PUBLIC INTEREST REVIEW FOR GROUND WATER APPLICATIONS

SUBJECT: Application G- 17158 Supersedes review of _____
Date of Review(s)

A. GENERAL INFORMATION: **Applicant's Name**: Birkemeier Farms Inc. **County: Clackamas**

A2. Proposed use: **Nursery Irrigation** Seasonality: **year-round**

Water Levels in Nearby Wells

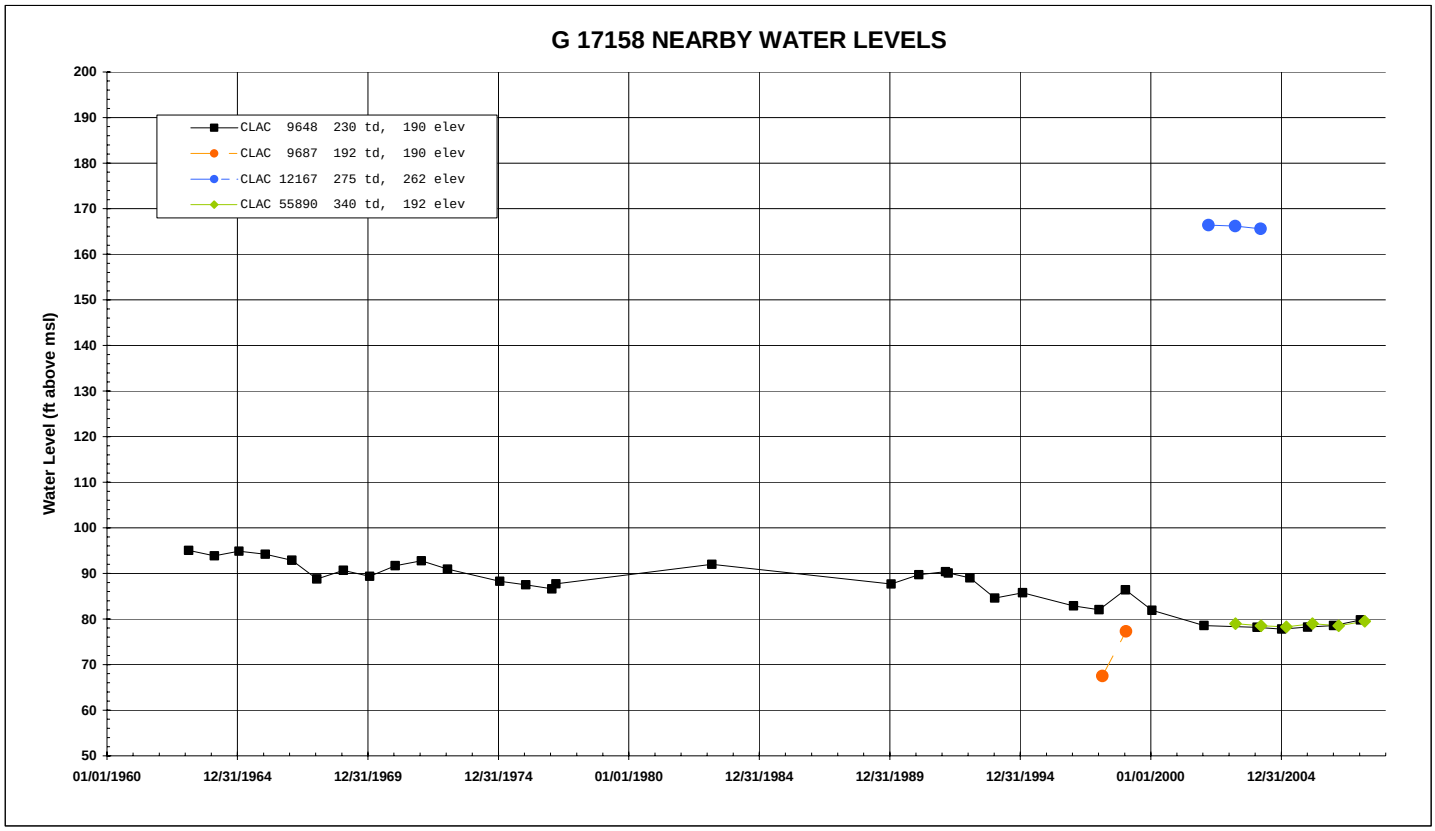
The applicant's well produces from water-bearing zones in the Columbia River Basalt Group (CRBG). The CRBG consists of a series of lava flows that range up to 1000 feet thick in the vicinity of the applicant's well. Most water in the CRBG occurs in confined aquifers that occupy thin rubble zones (interflow zones) that occur at the contacts between lava flows. The interiors of the basalt flows generally have low porosity and permeability and act as confining beds. This physical geometry generally produces a stack of thin aquifers (interflow zones) separated by thick confining beds (flow interiors). In the area of the applicant's well, the basalt aquifers are overlain by 200 feet of alluvial sediments. Because the aquifers are confined (storativity is estimated to be 0.0001), pumping impacts will propagate outward at rapid rates and reach aquifer boundaries (streams, faults, and truncated basalt flow margins) within a matter of minutes. Using aquifer parameters appropriate for the basalts, it can be shown that the cone of depression from a pumped well will produce measureable impacts at a distance of 1 mile within 1 hour. Therefore, hydraulic interference with nearby wells, springs, and streams will occur rapidly once pumping begins. The observance of significantly different water levels in nearby wells of different depths (see attached plot) suggests that there is a poor natural connection between overlying aquifers in the CRBG. This is illustrated by comparing nearby wells CLAC 9648 and CLAC 12167 which have March water-level elevations that differ by approximately 90 feet (see attached hydrograph).

The adequacy of the ground-water supply for the proposed use cannot be assessed with any degree of confidence because of the lack of long-term water level records for wells completed in the same water-bearing zones. The 7I decline condition, as stipulated by OAR 690-502-0250, should provide some protection for the resource and for senior users should declines become evident in the future.

B3. **Ground water availability remarks: SPECIAL CONDITION: The well shall not be deepened or altered such that water is produced from other aquifers in the Columbia River Basalt Group.**
